ADDENDUM NO. 1.0

Date: 08/15/2023

**Project: Project #: 0148-464
Leataata Floyd ES Telecenter Upgrade Project**

AD 1.17:

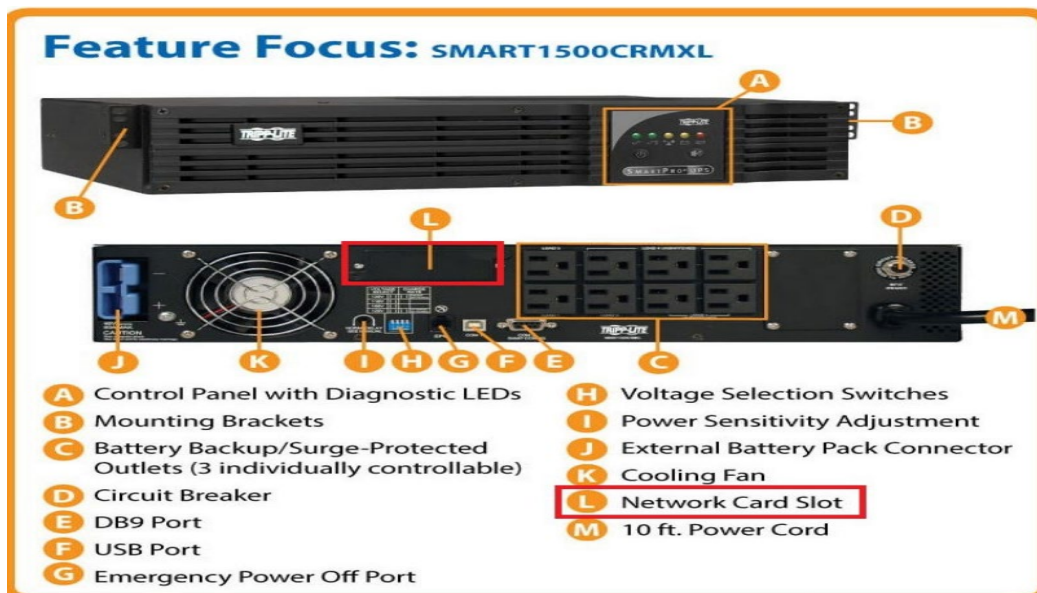
Question: Please advise if the battery backups shown on the one-line diagrams exist or to be furnished and installed by the contractor. If so, please also advise if a network interface card is required for each of these UPS battery backups to achieve network connectivity (shown below; and the one-line diagrams call for an RJ-45 connection to the battery backup as well). If so, please provide the part number and quantity of network interface cards required.

They need to be furnished. 1 per UPS. Part number to be supplied by manufacturer.
